PUBLIC HEARING MEMORANDUM

SUBJECT: **Petition #240-23** Request to allow ground floor residential use, to exceed by right height and stories, at 290 Watertown Street, Ward 1, Newton, on land known as Section 11 Block 14 Lot 03, containing approximately 11,473 sq. ft. of land in a district zoned BUSINESS 1. Ref: 7.3.3, 4.4.1, 4.1.2.B.3, 4.1.3, 5.1.4, 5.1.13 of Chapter 30 of the City of Newton Rev Zoning Ord, 2017.

290 Watertown Street

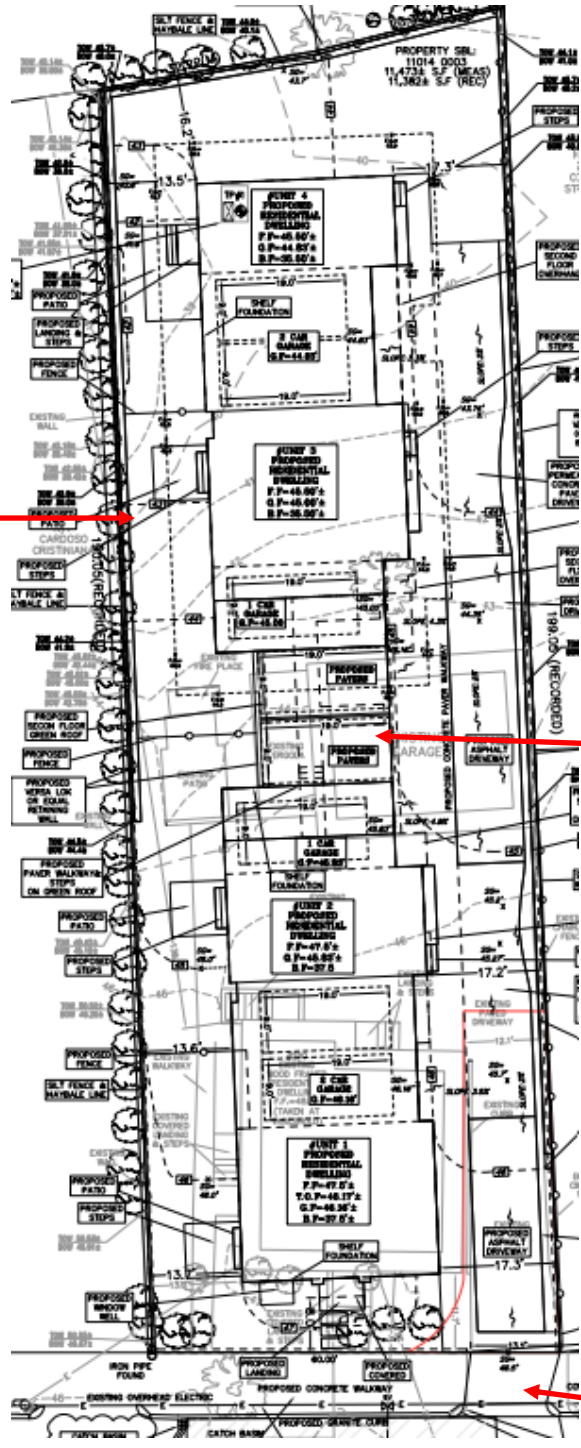
The existing structure has a nonconforming height of 29 feet, where 24 feet is the maximum allowed. The proposed residential structure would be slightly higher than the existing structure at 31.97 feet, which requires a special permit to allow the additional height above 24 feet. In addition, the structure is three stories where two stories are allowed by right in the BU-1 zoning district. Three-story buildings require a special permit in the BU-1 zoning district.

The proposed development meets all the required rear, side, and front yard setbacks for the BU-1 zoning district and provides a slightly larger front yard setback of 8.0 feet, correcting a non-conforming existing front setback of 6.7 feet. It also slightly enlarges the side yard setbacks compared to the existing house.

*290 WATERTOWN STREET
NEWTON
MASSACHUSETTS*

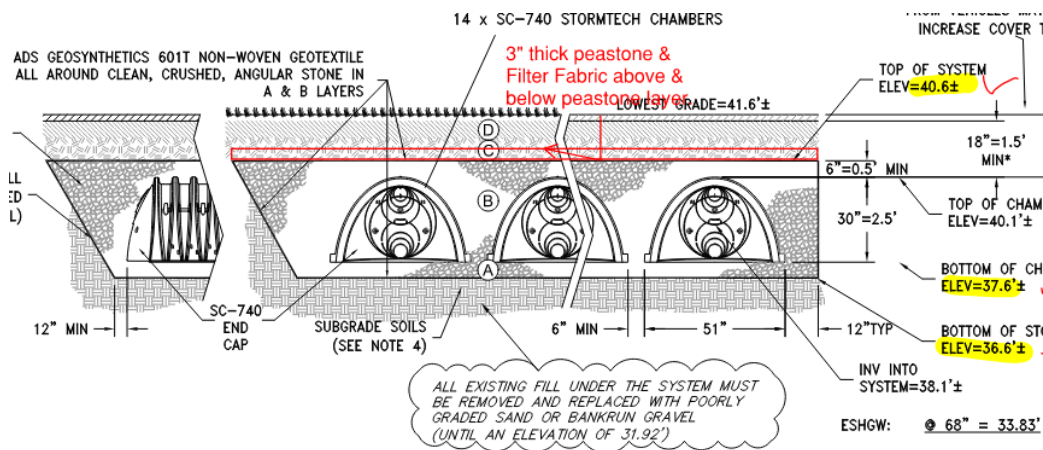
This proposed permit entails the demolition of an existing two-family unit and the construction of a 5-unit residential dwelling. The site has 60-feet of frontage along Watertown Street to the north, and residential dwellings to the south, east and western property lines. The site plan has a north arrow that is incorrectly rotated 180°. A high point elevation of 47-feet is near the front of the home and slopes gently to the northwest to a low point of 39-feet. The new dwelling will have on grade garages, a turning template plan should be submitted to demonstrate proper

maneuvering of various vehicle pulling into each garage and backing out to exit the site. I have a concern for snow removal and storage the applicant needs to explain where snow will be stored as the site does not have much open space along the driveway. On the average a 3-foot-high retaining wall within the setback is proposed along the east, south and western property lines the design needs to ensure that natural surface water flows are not impacted. The wall allows for the construction of flat side yards of patios and the access driveway.

The engineer of record has designed a stormwater collection system that meets the DEP & DPW Stormwater Regulations by collecting and infiltrating runoff from the driveway & roof within 14- infiltration units along the western & northern property lines. The proposed Operations & Maintenance (O&M) plan is acceptable for the design intent, however access to the units maybe problematic. A minor addition is need for the proposed infiltration system; the City requires a 3" thick layer of peastone with filter fabric above & below the peastone covering the entire system as shown below.

In accordance with the City Ordinance B-52 new concrete sidewalk, and granite curbing is required.
